**Project #21-040
Shepard Development
Located at 1766 Blacksmith Court**

<i>Project Name:</i>	Shepard Development
<i>Proponent / Owner:</i>	Justin Shepard / Shepard Development Co
<i>Project Address:</i>	1766 Blacksmith Court
<i>Request:</i>	Design Review Permit
<i>Current Zoning:</i>	Industrial Park (IP)
<i>Type of Action:</i>	Quasi-Judicial
<i>Hearing Date</i>	August 12, 2021
<i>Submitted By:</i>	Tanya Rice, Planner II

Staff recommends that the Planning Commission **conditionally approve** a Design Review Permit for Project #21-040, Shepard Development, for one industrial building located at 1766 Blacksmith Ct., TIN #02-089-0032.

Site Plan

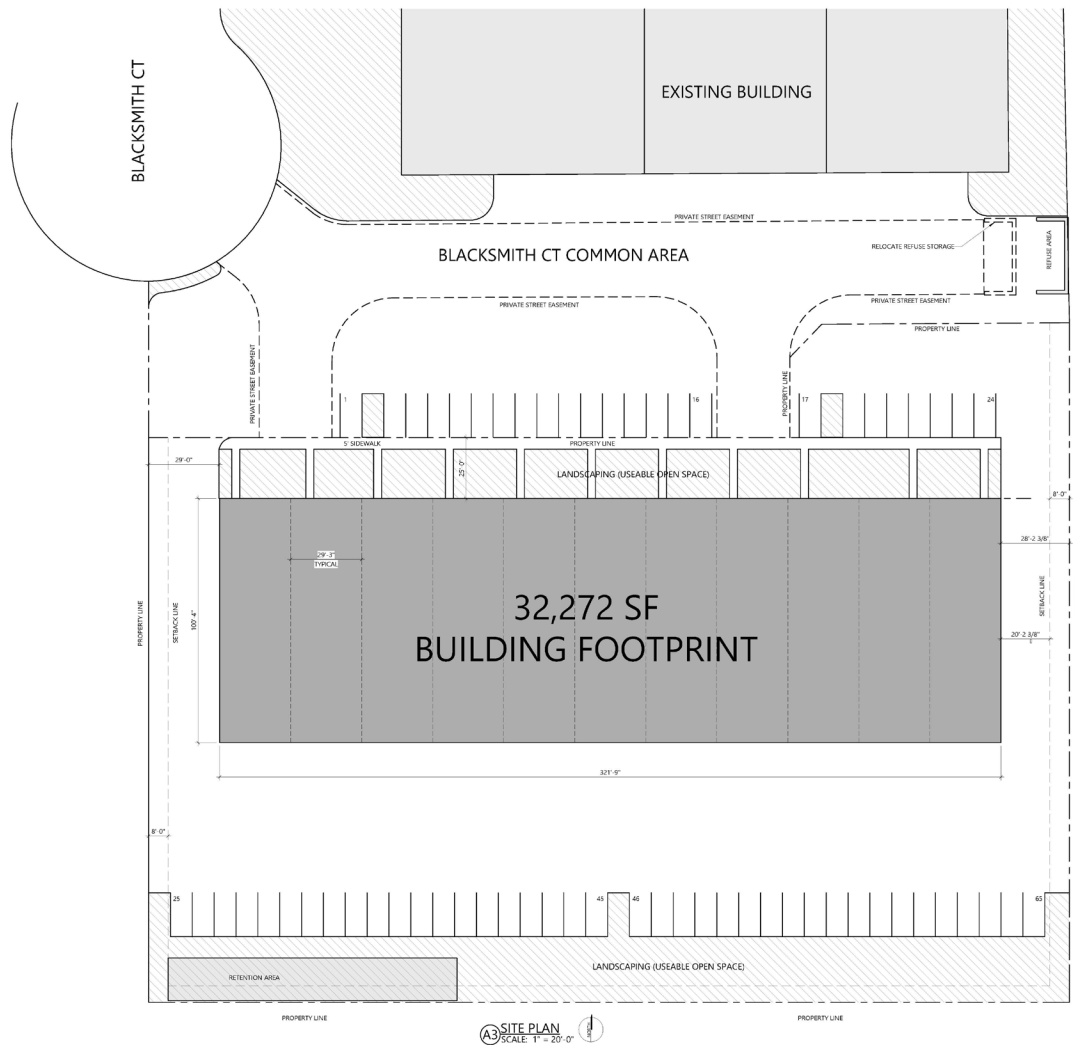
The LDC 17.31.090 requires industrial sites to include safe and convenient pedestrian circulation from the adjacent streets to buildings, parking areas and other outdoor gathering areas. The proposal includes sidewalk connections from the north parking area to the building but does not include walkway connections from the building to Blacksmith Court sidewalk.

As conditioned (#2), with the addition of pedestrian crossings/markings from the building entrances to the street sidewalks, the project complies with the requirements in the LDC.

Because of the shared common area, parking areas need to accommodate both the Trade Center and the proposed building. To calculate parking needs, the use of both buildings is categorized as a combination of office and warehouse/storage. The LDC 17.31.040 requires one parking stall per every 300 SF of office space and one parking stall for every 2,000 SF of warehouse/storage space. The applicant has indicated that the approximate building space breakdown will be 75% warehousing and 25% office/administration, as is the same for the Trade Center. The total square footage of both buildings is approximately 51,000 SF and requires 62 stalls. The proposal includes 65 stalls which complies with the LDC.

The proposed project does not include a required bike rack. As conditioned (#3), the proposed project meets the minimum bike parking requirements in the LDC.

The LDC 17.31.140 requires parking areas to include landscape islands every 20 parking stalls. The proposed parking lot shall incorporate the required breaks to comply with the LDC.

Plant material is also required to be planted around the perimeter of the building where feasible. The proposal includes landscape in the front of the building but is not included on the sides or rear of the building. Given the nature of the project and potential uses, it would be more appropriate to place this landscaping into the boundary landscaped areas to ensure survivability.(NICE TRY) As conditioned, with a landscaping plan (#5), the project complies with the requirements of the LDC.

1. All standard conditions of approval will be recorded with the Design Review and are available in the Community Development Department.
2. Pedestrian crossings/markings shall connect the building to Blacksmith Court sidewalk.
3. A bike rack sized to accommodate three (3) bikes shall be provided.
4. An unpaved two (2) foot setback shall be maintained between the property line and the driveway along the east and west sides of the property.

Front Façade

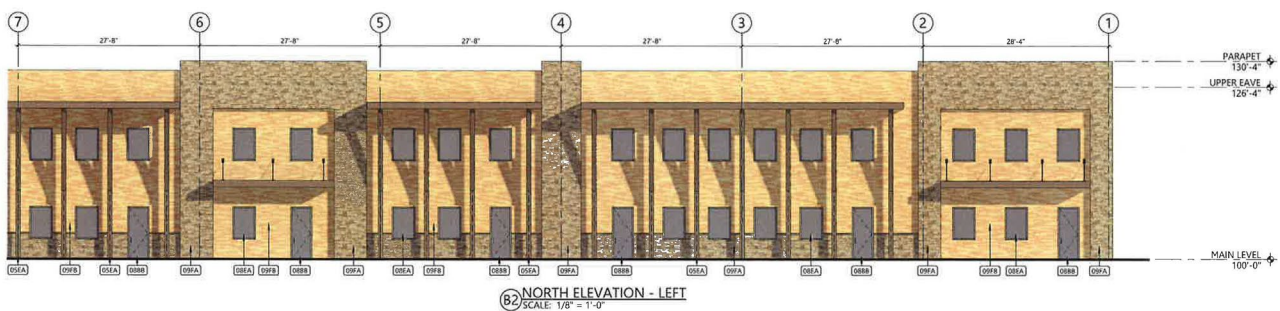
The proposed building is a single structure with the primary siding materials being comprised of stone and wood. The design incorporates painted steel awnings, compatible finishes and color palette. The proposed window and door layout meets the 30% fenestration requirement along the front façade.

The LDC requires ground-floor entrances on the facades visible from public streets to be easily discernable while utility doors, fire doors, and loading docks are to be designed to blend with the building's architecture. The proposed front entrances have staggered covered canopies providing variation in architecture and easily discernable entrances. All proposed utility doors and service features are at the rear (south) of the building and are not visible from a public road.

The LDC 17.10.030 limits base building height to 48' in the IP zone. The highest point of both the building is 30' to top of the parapet. As proposed, the project complies with the requirements in the LDC.
